**TOWN OF NEWBURGH
PLANNING BOARD
TECHNICAL REVIEW COMMENTS**

PROJECT: CVS PHARMACY/STORE
PROJECT NO.: 15-23
PROJECT LOCATION: SECTION 60, BLOCK 3, LOT 5.2
PROJECT REPRESENTATIVE: CUDDY & FEDER, LLP
REVIEW DATE: 30 NOVEMBER 2015
MEETING DATE: 3 DECEMBER 2015

Re: Response to Technical Review Comments
CVS/pharmacy
Section 60, Block 3, Lot 5.2

SHEET NUMBER:
C-2

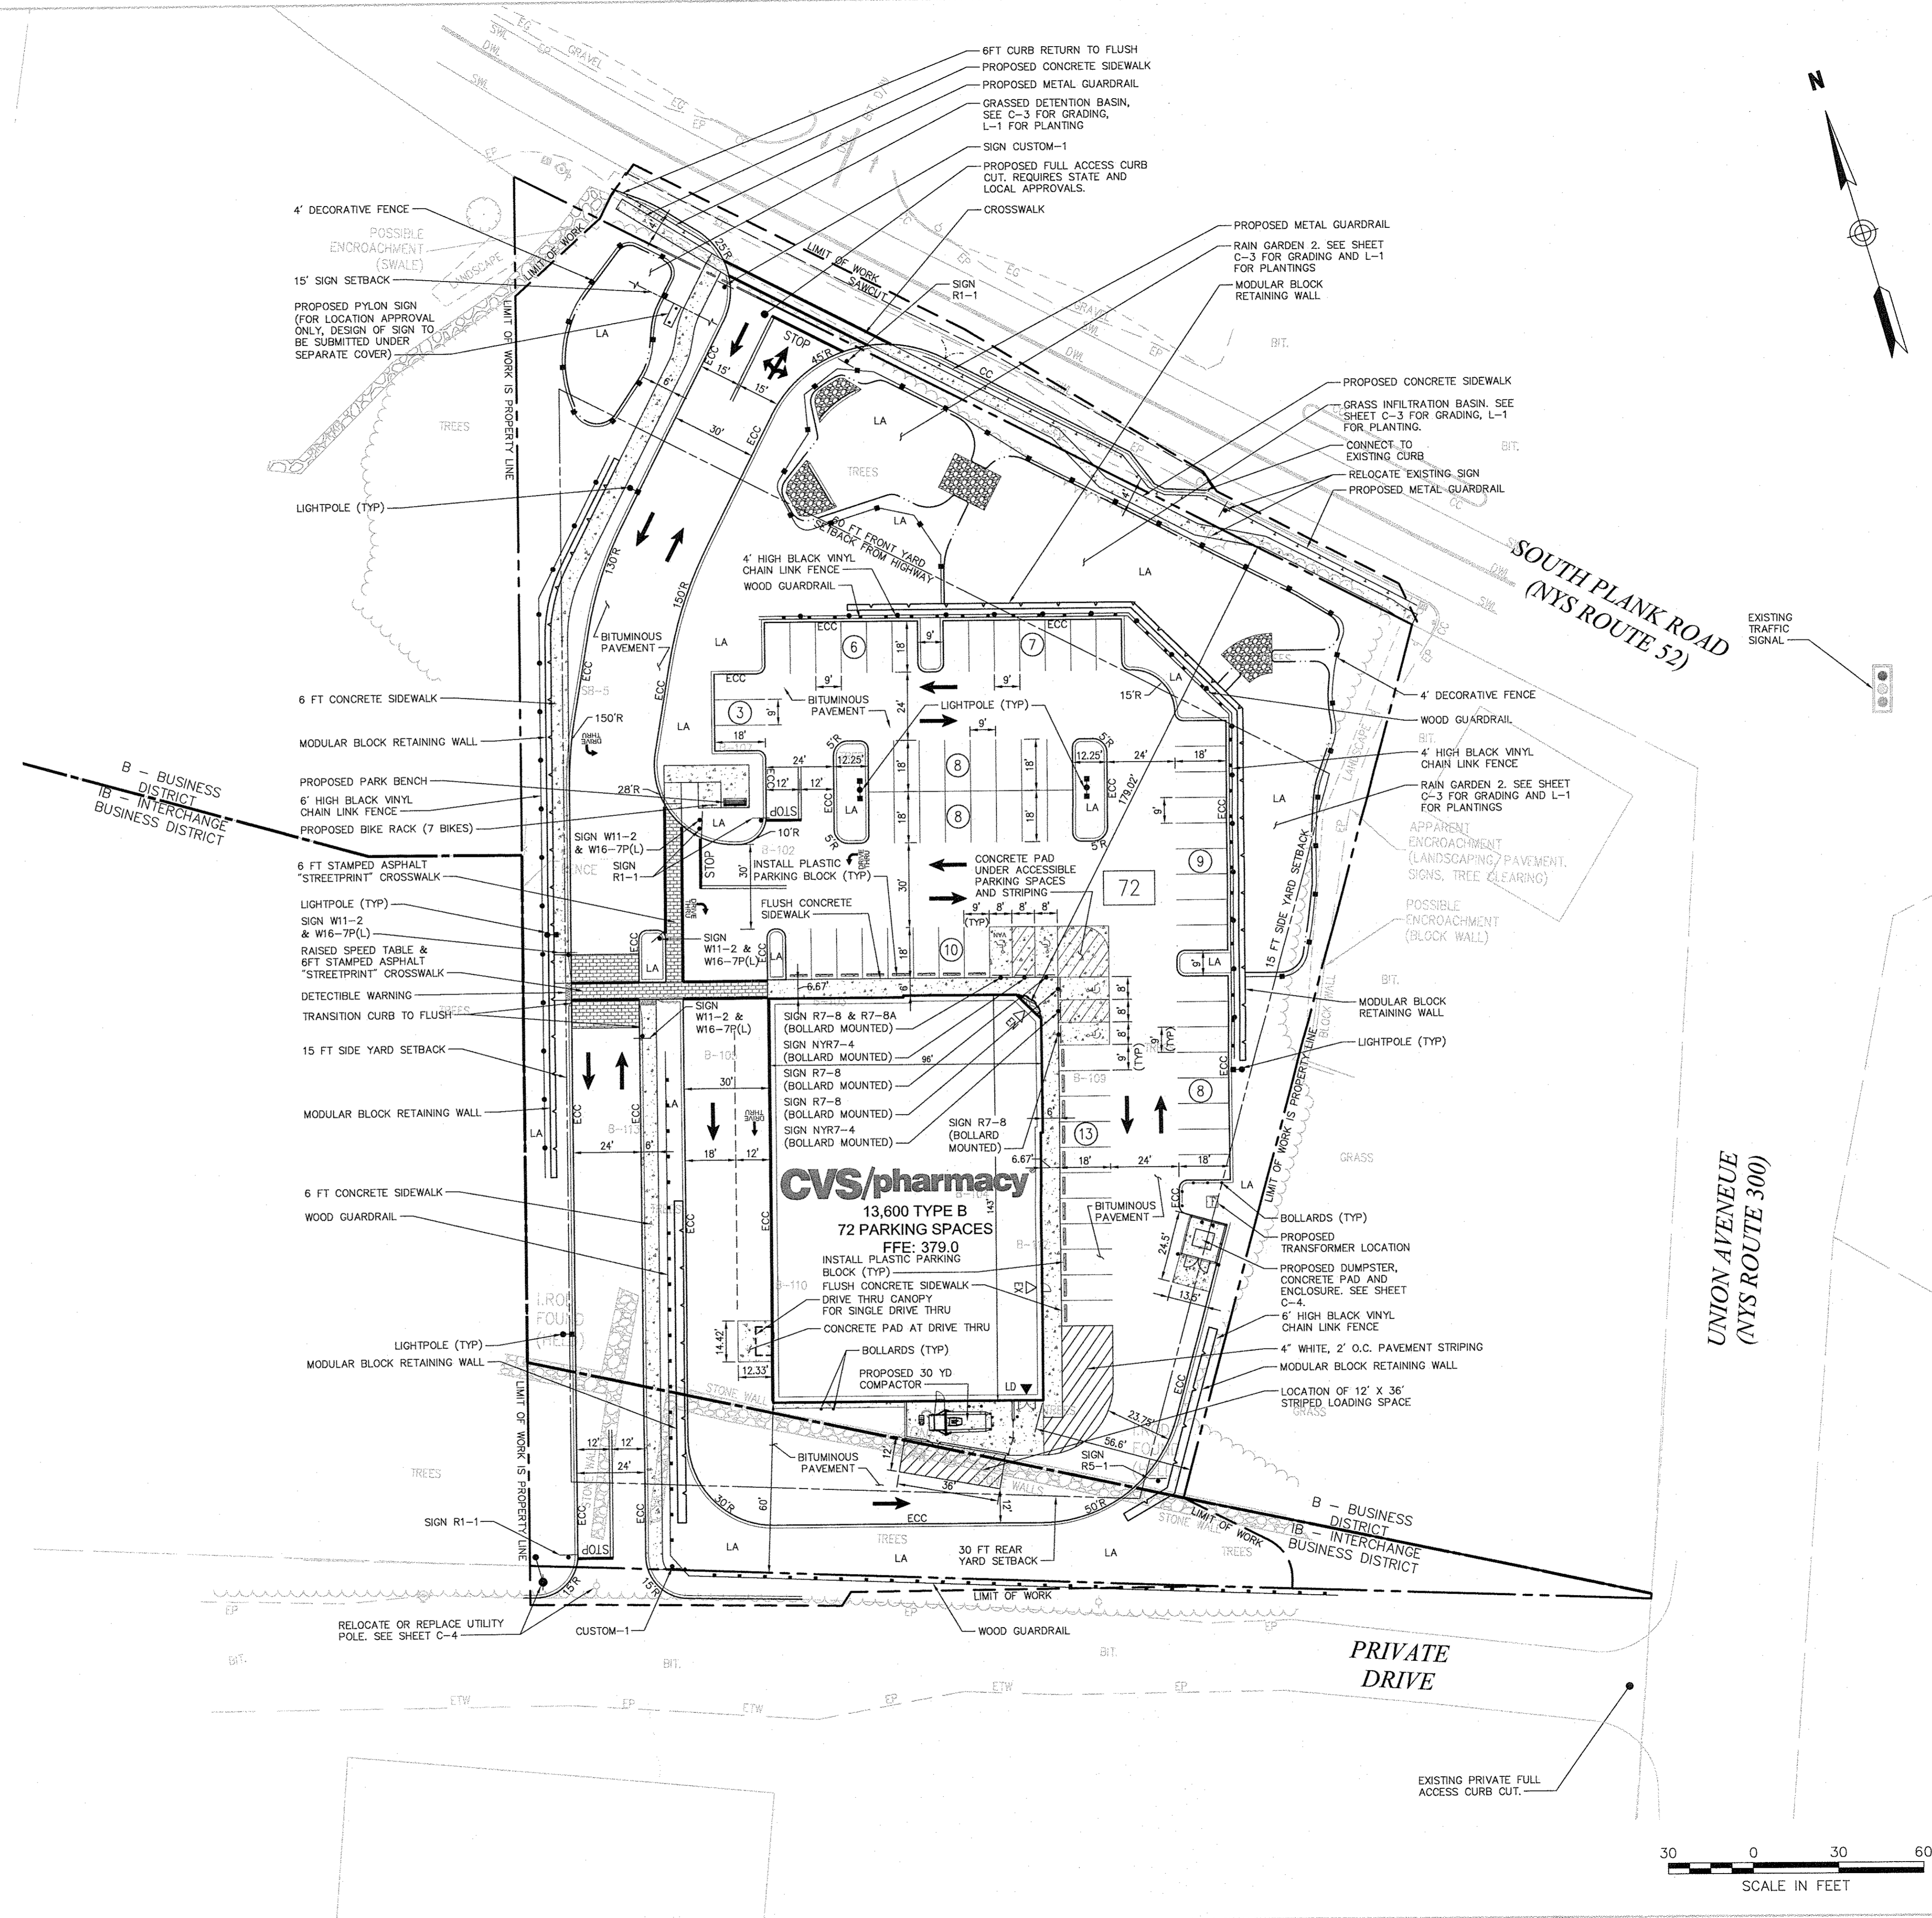
Comment 1: The proposal reduces the 6 to 7-foot shoulder on Route 52 to about 1-foot at the entrance to the site. What's the purpose for this?

Comment 3: The sidewalk leading up the west side of the driveway to the store should terminate with a curb ramp at the site driveway near Route 52. As it's currently shown, it ends in the grass.

Response: **The site plans have been revised and curblines adjusted to gain the 6-7 foot shoulder on Route 52. The previously existing shoulder was gravel and not paved. The proposed plans now accommodate a paved shoulder. See sheet C-2.**

Response: **The Layout & Materials Plan sheet C-2 has been revised with the addition of a sidewalk along the frontage of the site. With the addition of this sidewalk, the**
